**City of Portland, Maine – Building or Use Permit Application** 389 Congress Street, 04101, Tel: (207) 874-8703, FAX: 874-8716

Location/Address of Construction: <i>27 Copley Woods Circle Lot #6</i>			
Total Square Footage of Proposed Structure <i>1460 SF</i>		Square Footage of Lot <i>7305.3 SF</i>	
Tax Assessor's Chart, Block & Lot Number Chart# <i>413</i> Block# <i>B</i> Lot# <i>006</i>		Owner: <i>KTO Builders</i>	Telephone#: <i>892 2058</i>
Lessee/Buyer's Name (If Applicable)		Owner's/Purchaser/Lessee Address: <i>13 Varney Mill Windham, ME 04062</i>	Cost Of Work: <i>\$65,000</i> Fee: <i>\$414</i>
Proposed Project Description:(Please be as specific as possible) <i>Construct a 26x34 Single Family dwelling with a 24x24 Attached Garage</i>			
Contractor's Name, Address & Telephone <i>KTO Builders 13 Varney Mill Rd Windham, Maine 04062 892 2058</i>			Rec'd By:

RE: 27 Copley Wood Circle (lot#6) 413-B-006  
31 Copley Wood Circle (lot #7) 413-B-007  
R-3 PRUD Development

CHECK-LIST AGAINST ZONING ORDINANCE

# 27 COPLEY WOODS CIRCLE

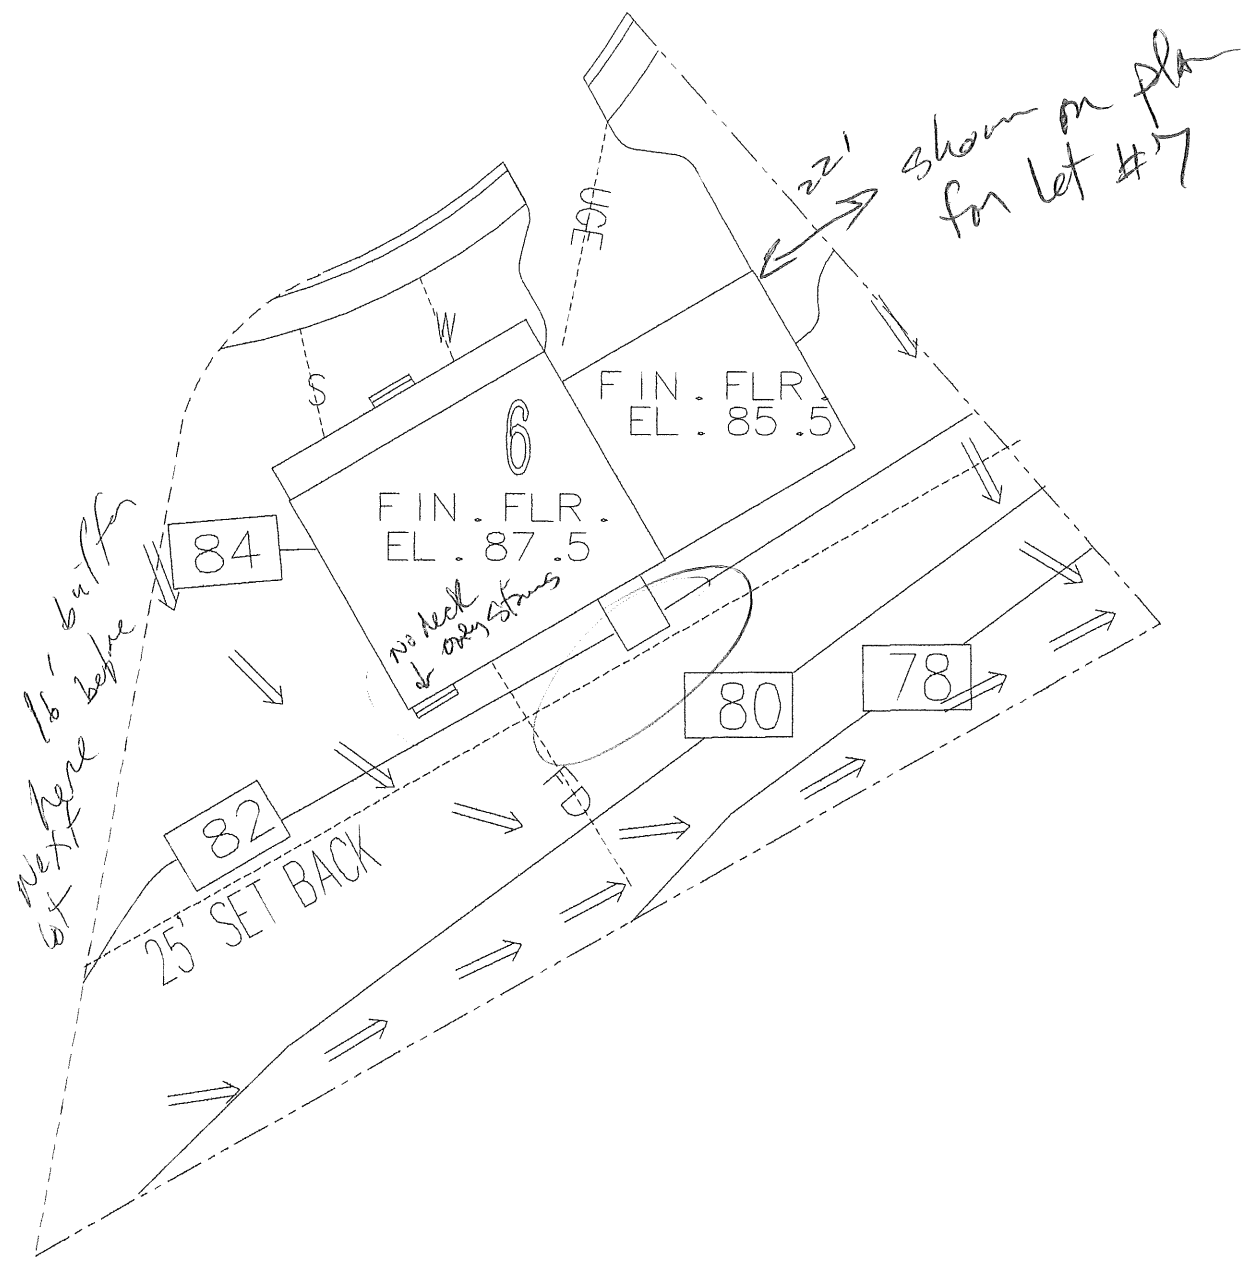
Lot Street Frontage - ① minimum bldg setback from external subdivision property lines 25' req - 26' shown

Rear Yard - ② min. distance between detached PRUD dwelling units 16' req - 16' + 9' 22' shown

Projections - rear bulkhead front stairs ③ recreation areas shall be located at least 25' from dwelling units - 25' shown

Height - 24.5' shown

# 27 COPLEY WOODS CIRCLE

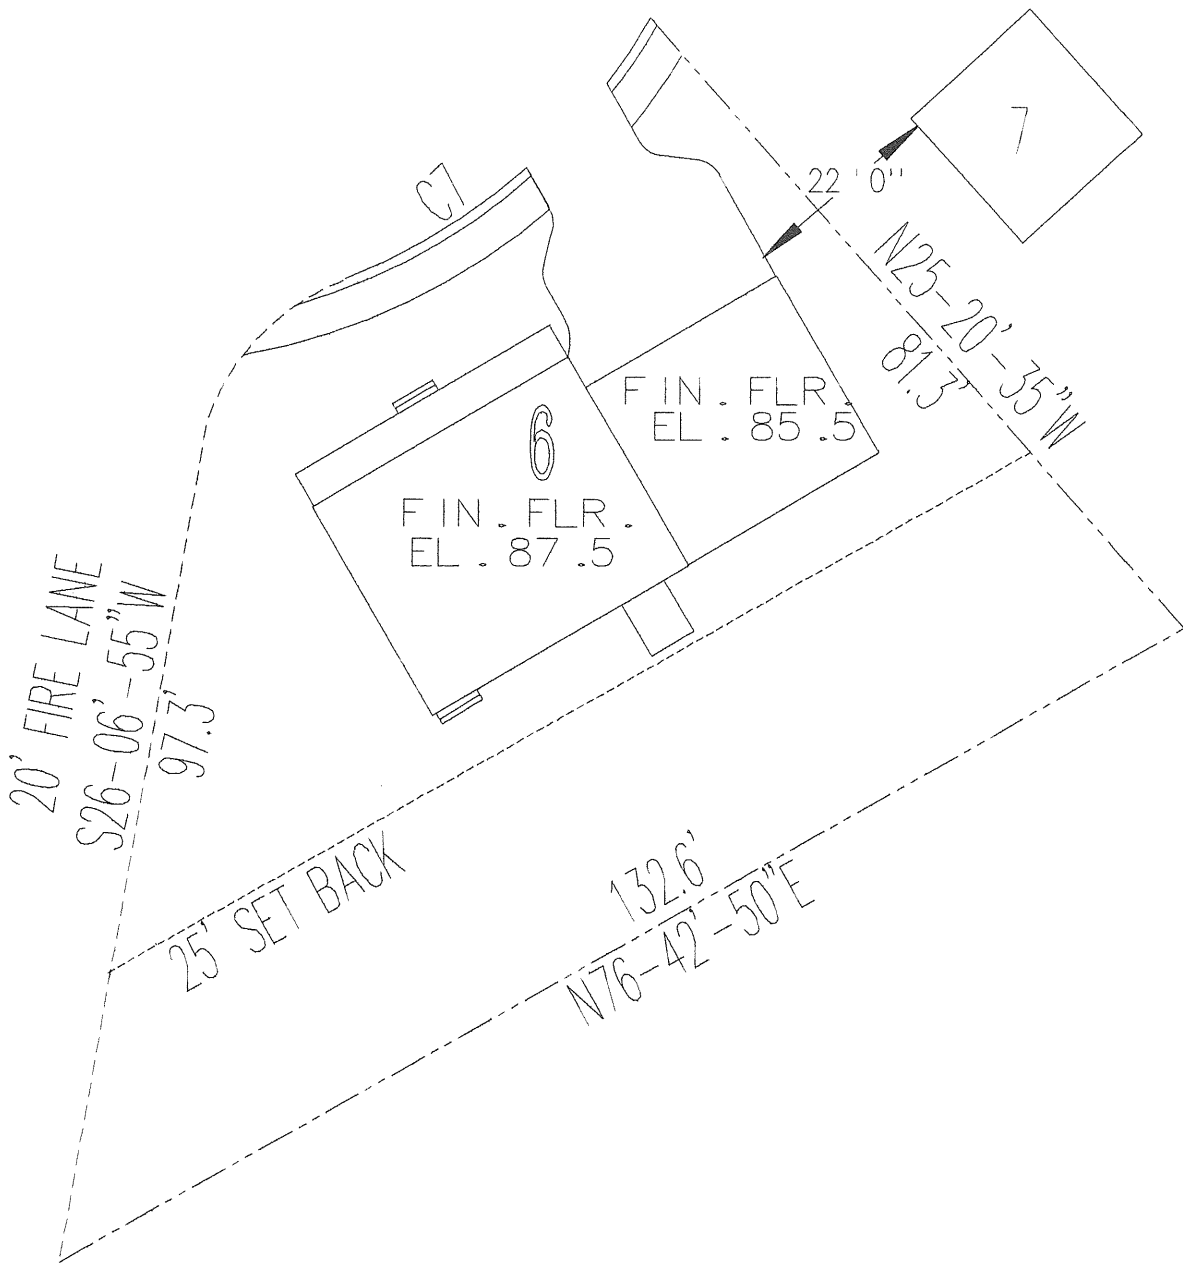
**27 Copley Wood Circle (lot #6)** The structural plans and the plot plan do not match. The house and garage appear to be reversed from one another on each plan. The house plan also shows a simple front door with a small deck and steps to the ground. In magic marker scrawled in is "4' x 32' farmers porch". The plot plan shows a porch the length of the house. I should not have to choose or guess what plan is being used. You need to show us exactly what you intend to build so that we can properly review your plans for compliance.

*See Revised  
plans received  
9/10/99*

# 31 COPLEY WOODS CIRCLE

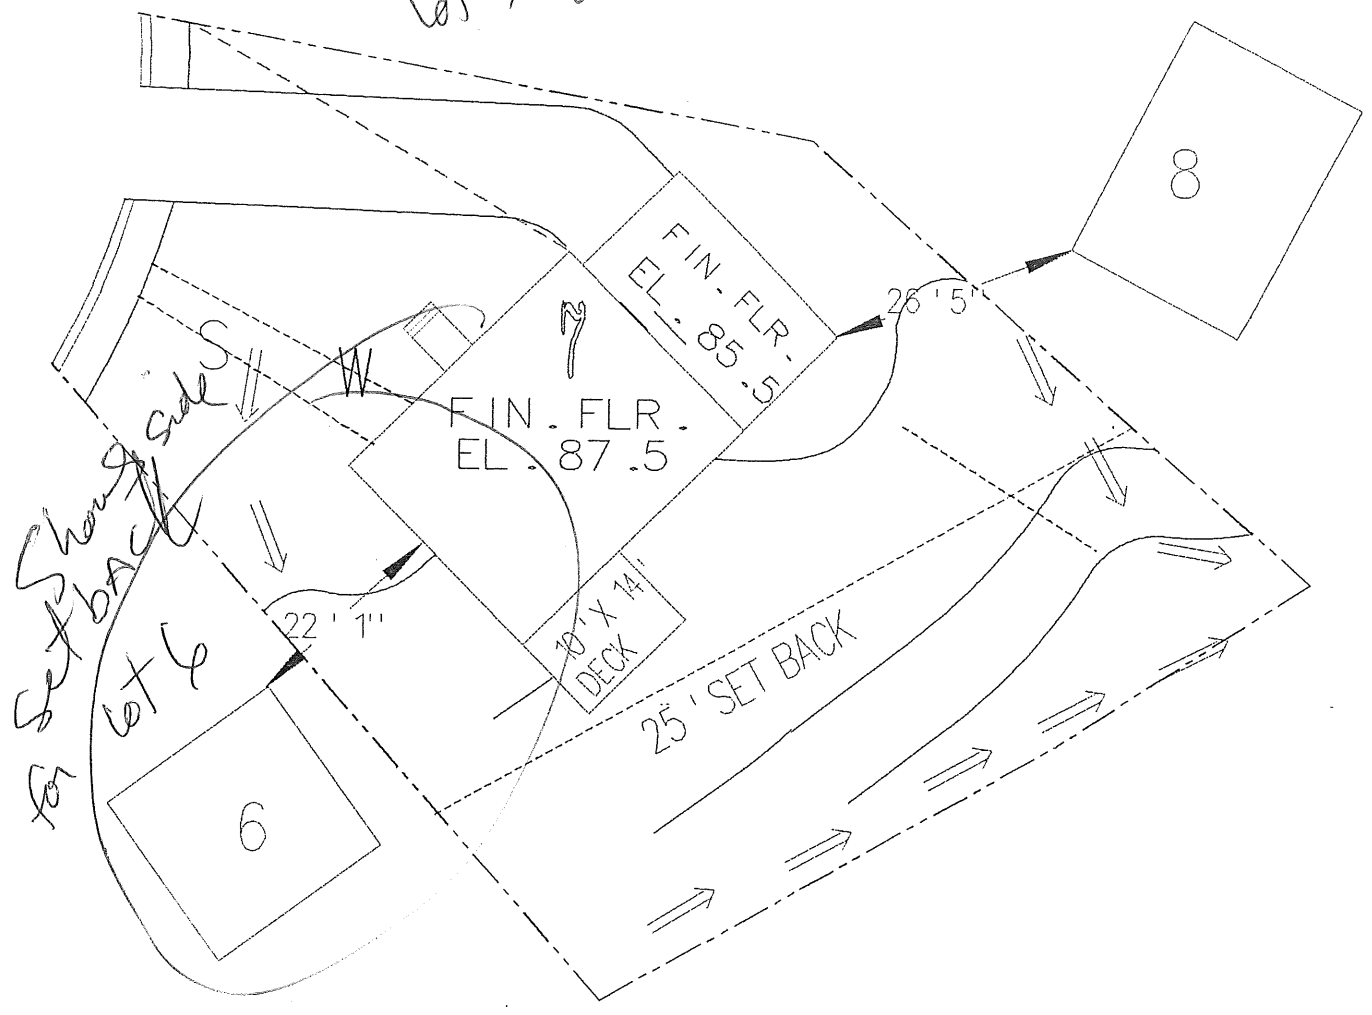
**31 Copley Wood Circle (lot #7)** Again the structural plans and the plot plan do not match. The house and garage appear to be reversed from one another on each plan. Since 16 feet is required between detached PRUD units, I need to see the house footprint location on lot #8 on your submitted plot plan to insure that the side setback requirement between structures is being met. The most serious problem I have is, if I have guessed right, the bulkhead that you have propose on the rear of the house would project into the 25 foot required setback from the external property line. As I have measured, you would have a 22 foot setback instead of the required 25 foot. This bulkhead projection is not shown on your plot plan. It is required to be shown accurately on your plot plan. That issue also must be resolved before the issuance of this permit.
